Docket Item # 4 BAR CASE # 2008-0169

BAR Meeting October 15, 2008

ISSUE: Alterations

LOCATION: 728 South Lee Street

Figure 4: Proposed Rear Elevation

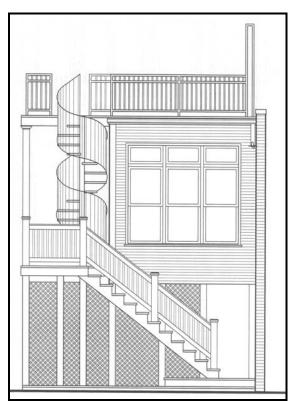
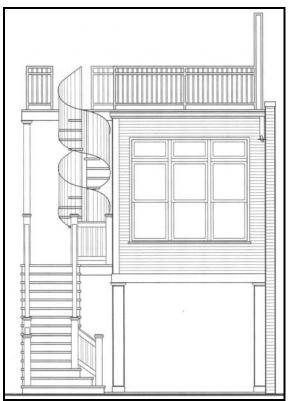
In Staff's opinion the design of the replacement stairs will be an improvement to the rear elevation of 728 South Lee Street and a more constructive use of space than the existing stairs. The new stair configuration creates a net gain of 21 square feet of open space. Staff finds that the proposed stairs follow all of the criteria set forth in the design guidelines concerning the construction of exterior staircases.

IV. STAFF RECOMMENDATION: Staff recommends approval of the application as submitted.
